CITY OF SANTA ANA

Application Description: Expanding existing unit 500 into 550 & 555: Adding demising walls, locker rooms, add non-bearing partitions, realign ceiling and mechanical systems

TENANT IMPROVEMENT PLAN CHECK COMMENTS

PLAN CHECK NO:	10173124	
PROJECT ADDRESS:	200 W Santa Ana Blvd Unit# 500	
PLAN CHECK ENGINEER:	Mazarji, Zac	TEL: 714 647-5831
		FAX: 714 647-5897
TYPE OF CONSTRUCTION:	I A, SPK	
OCCUPANCY CLASSIFICATION(S):	B	
PLAN CHECK DATES:		REMARKS/RECHECK ITEMS:
APPLICATION	9/6/2011	
INITIAL REVIEW	9/7/2011	
EXPIRATION	3/4/2012	
RECHECKS:	1. 2. 3.	PROJECT APPLICANT CONTACT PERSON: Fraser McClellan
VALUATION:	\$300,000.00	TEL: (714)897-3382
FLOOD ZONE:	X-0602320276J	FAX: (714)897-5952
		EMAIL: Fraser@FMAcorp.com

3RD LEVEL PARKING PLAN 1/8"=1'-0" 02

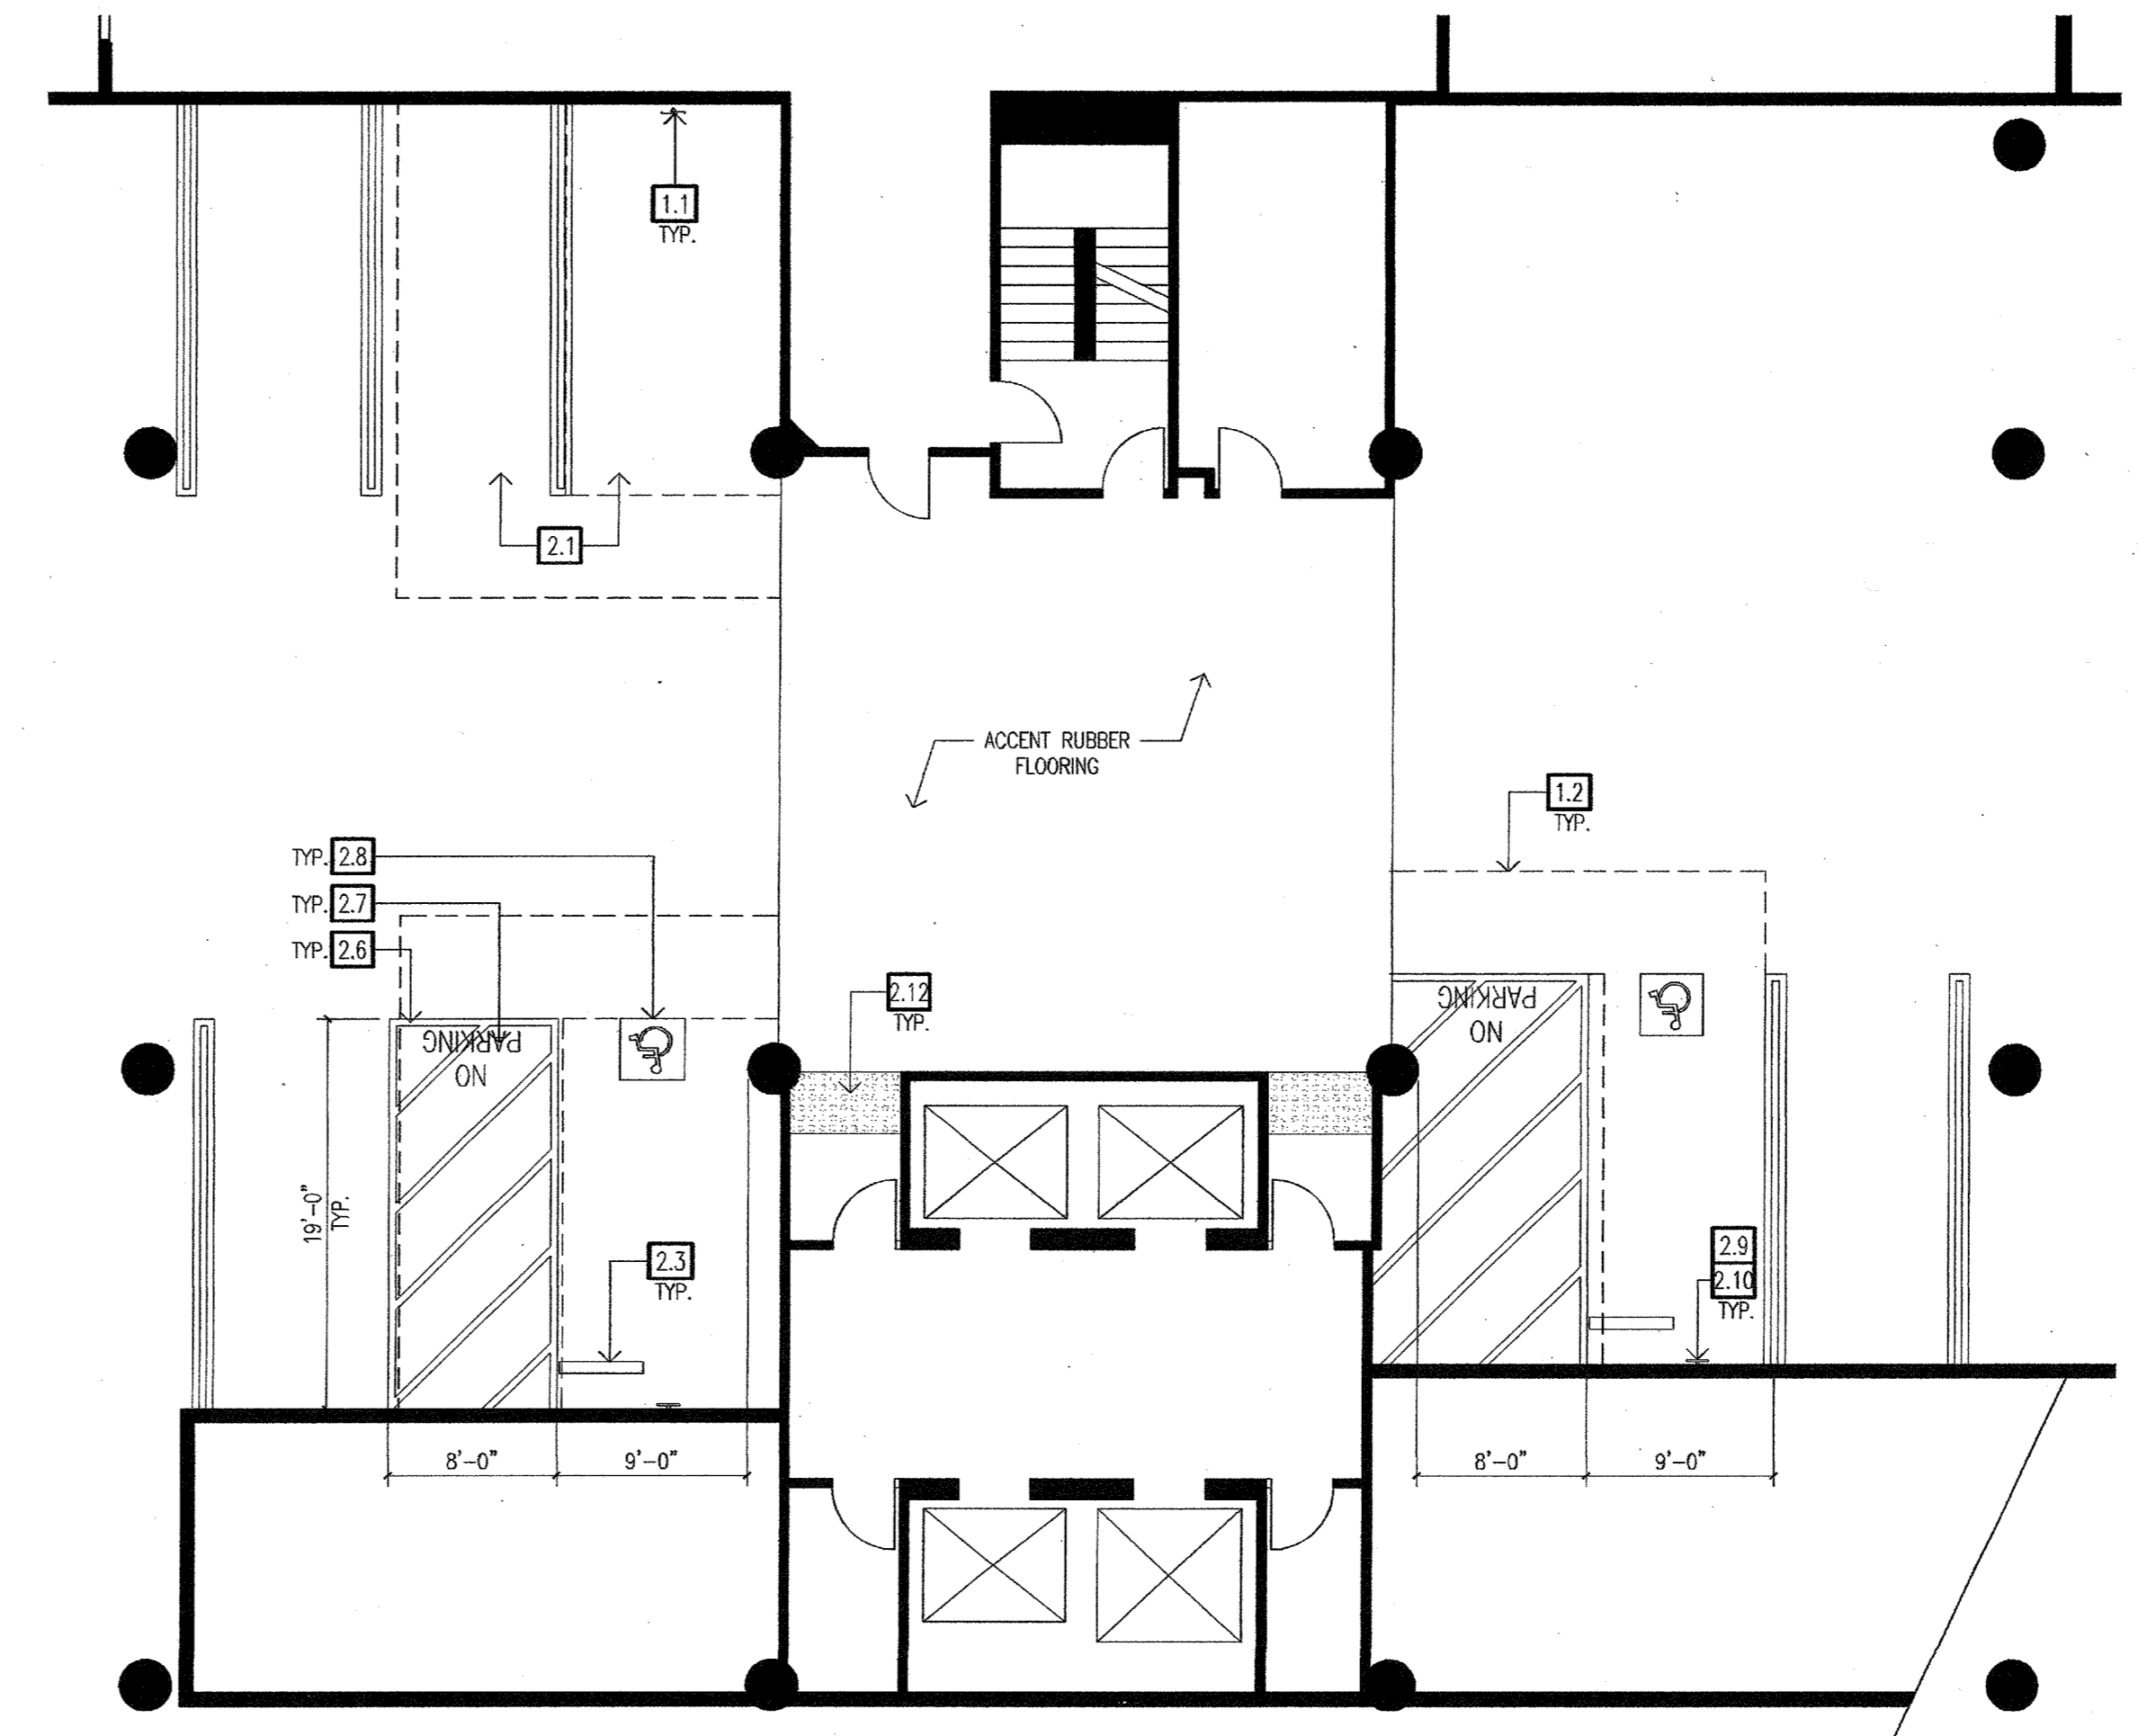
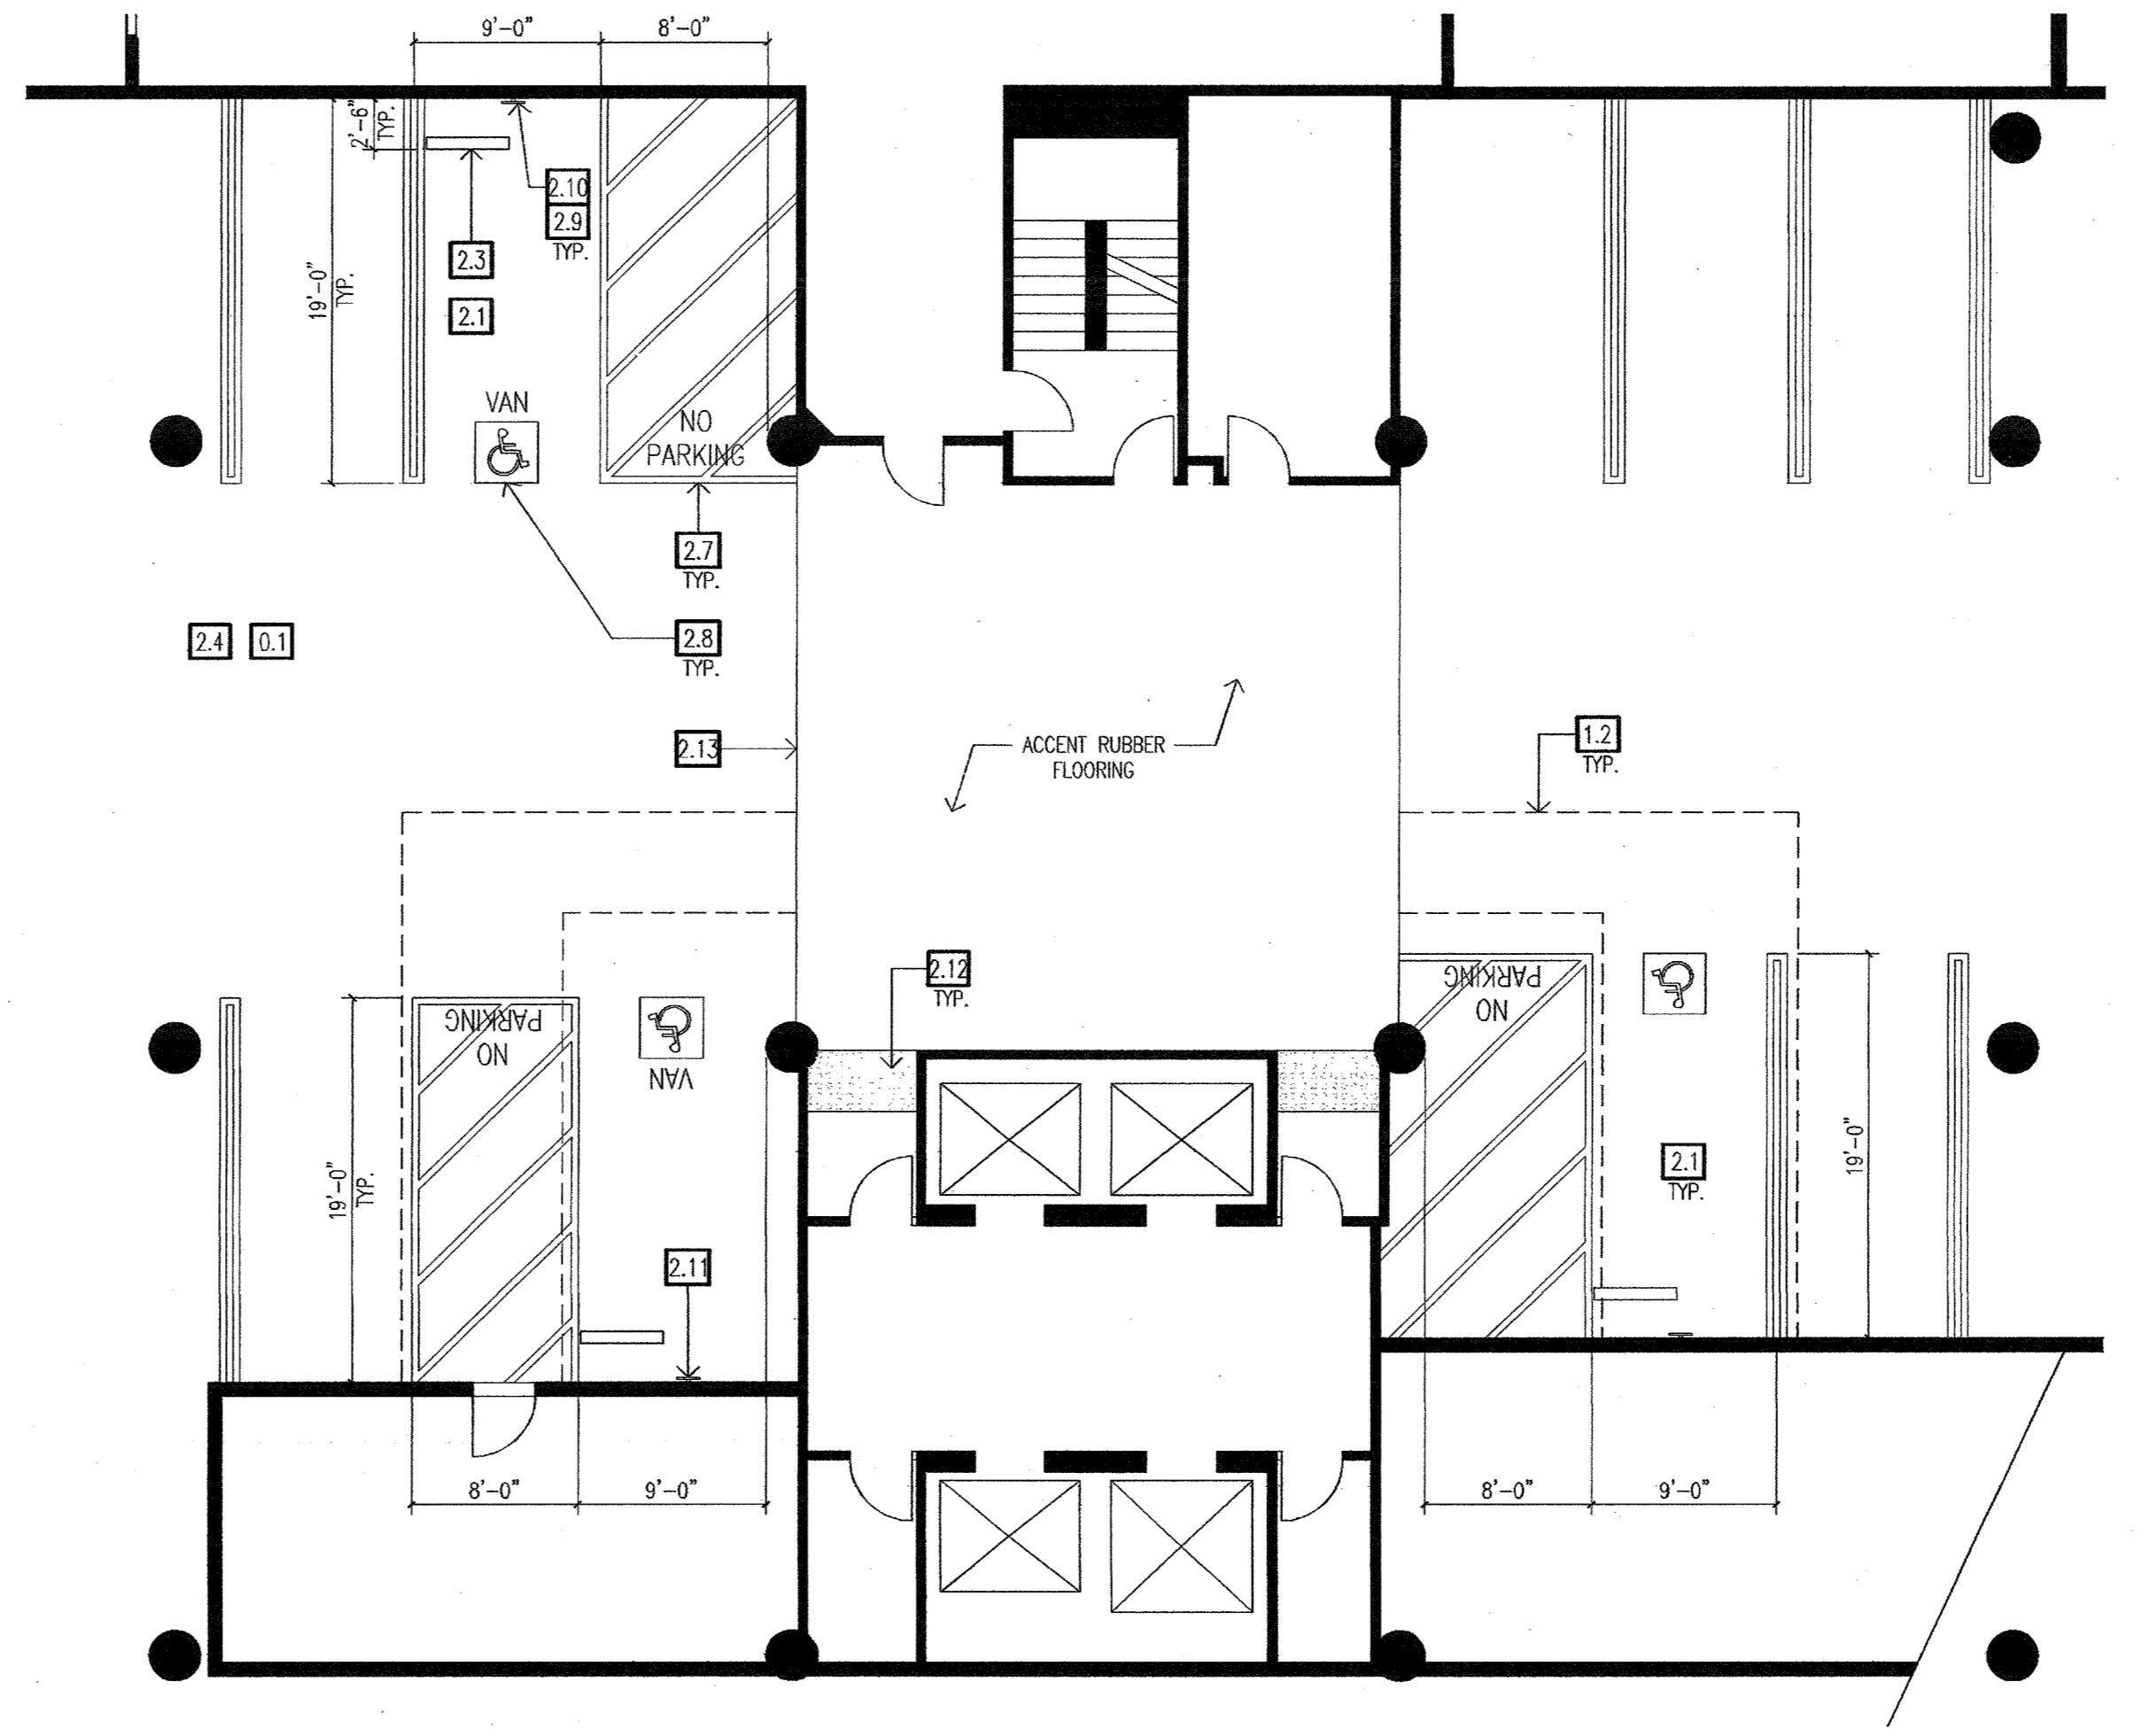
36. **Provide parking space identification in accordance with CBC Section 1129B.4 including:**

- CORRECTIVE WORK**
- 2.1 NEW STALL STRIPPING AS SHOWN ON PLAN
 - 2.2 PROVIDE NEW POST AND WALL MOUNTED SIGNS AT ALL STALLS. SEE SIGNAGE DETAILS ON THIS SHEET
